**Staff Report: 8711 Georgia Avenue
Project Plan Amendment 92005002A
Site Plan 820080320**

DATE: October 23, 2008

DESCRIPTION: Amend the Project Plan to reduce the minimum building setbacks, connect the parking access driveway to the future Fenton Street extension to the east, modify the design of the on-site public use space, and relocate the stormwater management facilities. The Site Plan proposes 152,740 gross square feet of mixed-use development, with 148,278 square feet of office use above 4,462 square feet of ground-floor commercial uses, on 0.87 acres in the CBD-2 Zone; located on the east side of Georgia Avenue, 250 feet north of the intersection of Georgia Avenue and Cameron Street, in the Silver Spring CBD Sector Plan.

Georgia Avenue Elevation

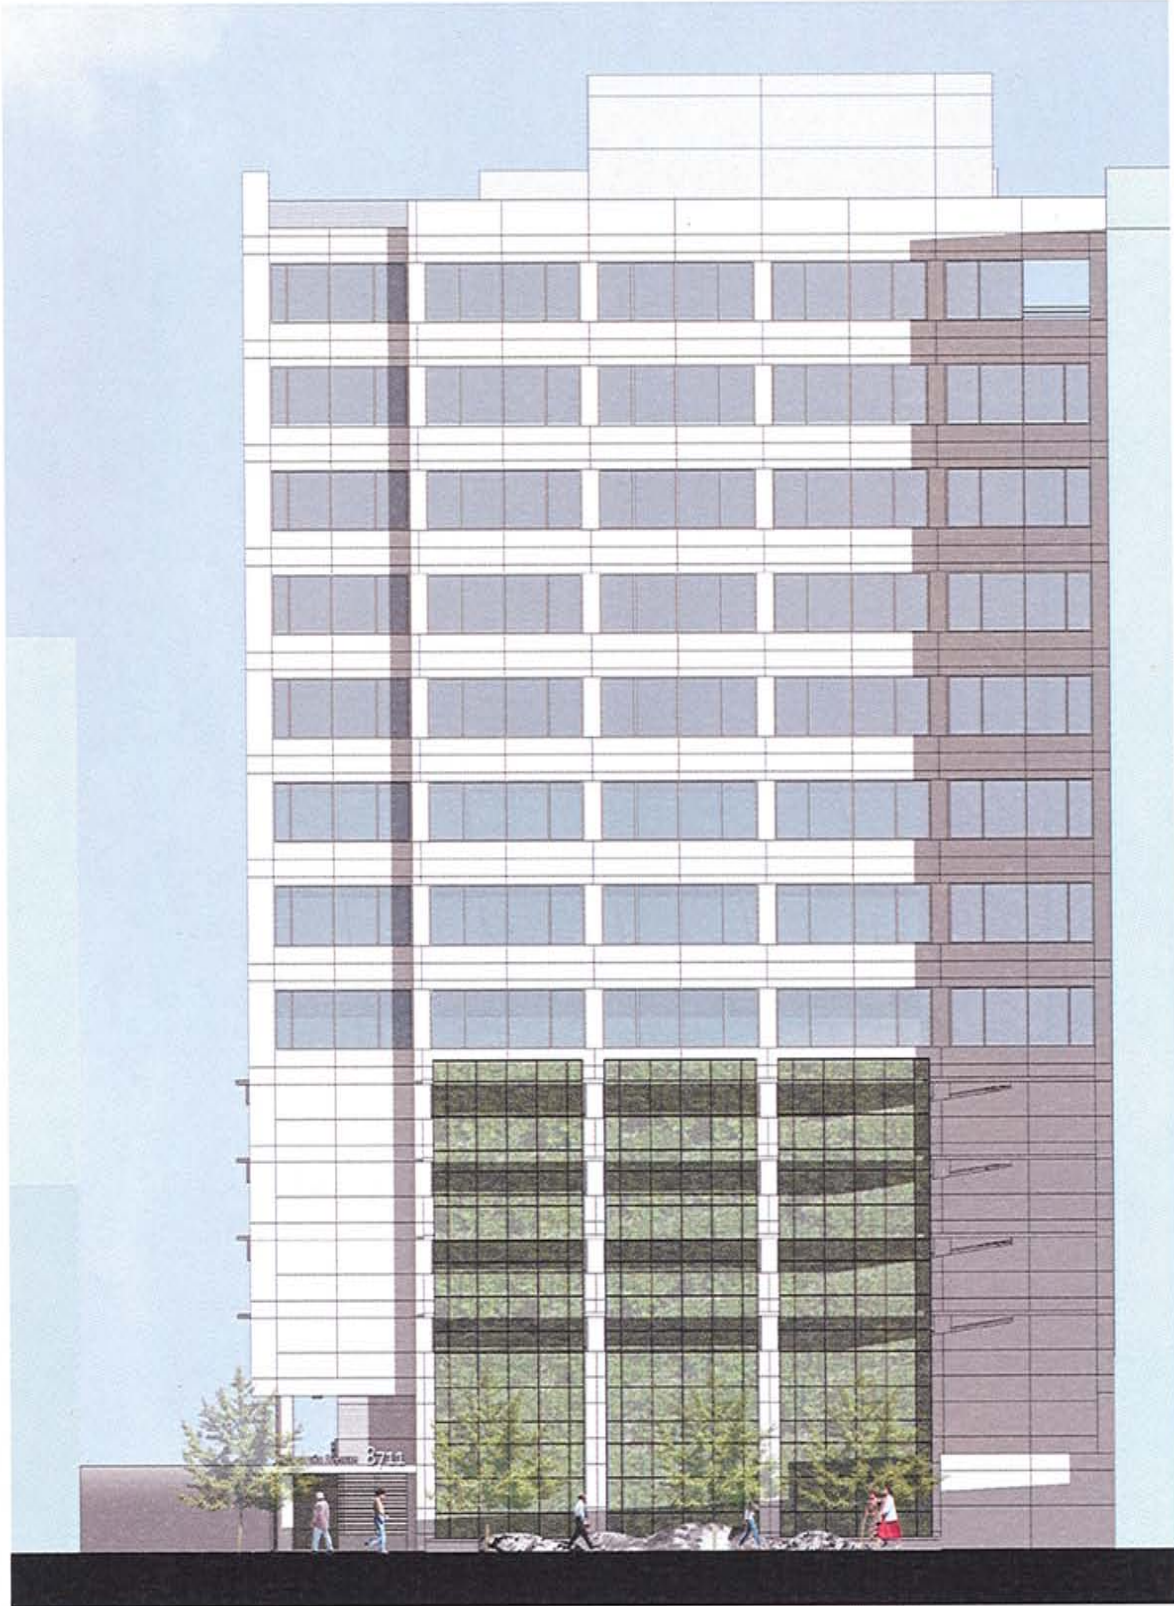
- i. on the south corner of the building, on Georgia Avenue, an illuminated entry feature similar to that illustrated on the "south" and "east" elevations on Sheet A.04 of the submitted architectural plans;

- ii. on the west-facing partial-floor building return located overhead within the pedestrian arcade (at the fifth bay from the north side of the building, as illustrated on the east elevation on Sheet A.04), adjacent to the driveway, an illuminated "way-finding" feature readily visible from the entry feature described above in condition 4.a.i;

- c. The exterior architectural character, proportion, material, and articulation must be substantially similar to the schematic elevations shown on Sheet A.04 of the submitted architectural drawings, as determined by M-NCPPC Development Review and Urban Design staff;

Parking Garage 2 Driveway, with Retaining Wall, looking South

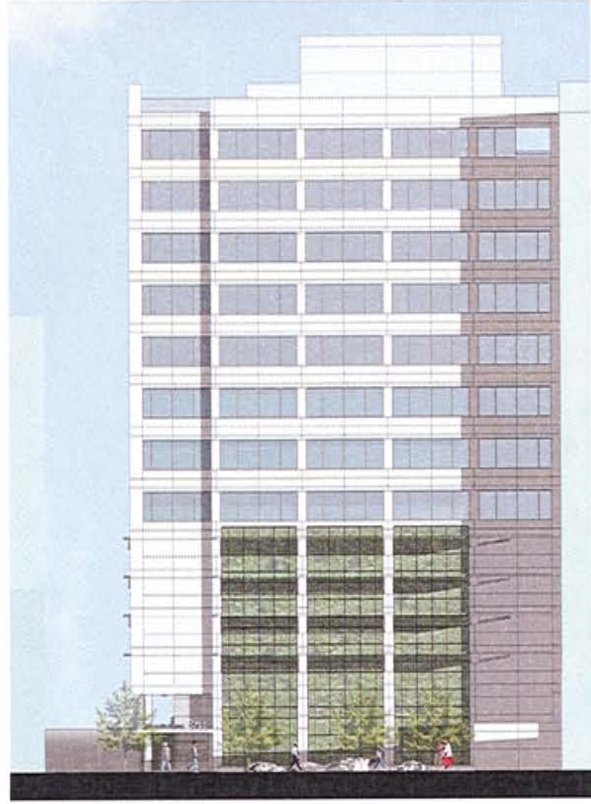
There remains a degree of uncertainty regarding the near-term disposition of the existing retaining wall and sidewalk along the Public Parking Garage 2 driveway, depicted below. The Applicant is in the process of finalizing an access arrangement with the Parking Lot District. This arrangement will have to address the status of the walk and wall. Staff strongly recommends that the wall come down. The Board specifically conditioned its approval of the original Project Plan on the Applicant’s coordination with the PLD for such a removal.

Whatever the short-term fate of the retaining wall, the Applicant and staff share a vision of this future extension of Fenton Street, and the Applicant's design team has worked to produce a site and building design that provides, to the greatest degree possible given the constraints of the zoning, site, and building program, a building with two "fronts." The entry feature at the south corner of the building along Georgia Avenue announces a pedestrian arcade connecting visually and physically with building entry graphics and design elements on the arts plaza on future Fenton Street extended.
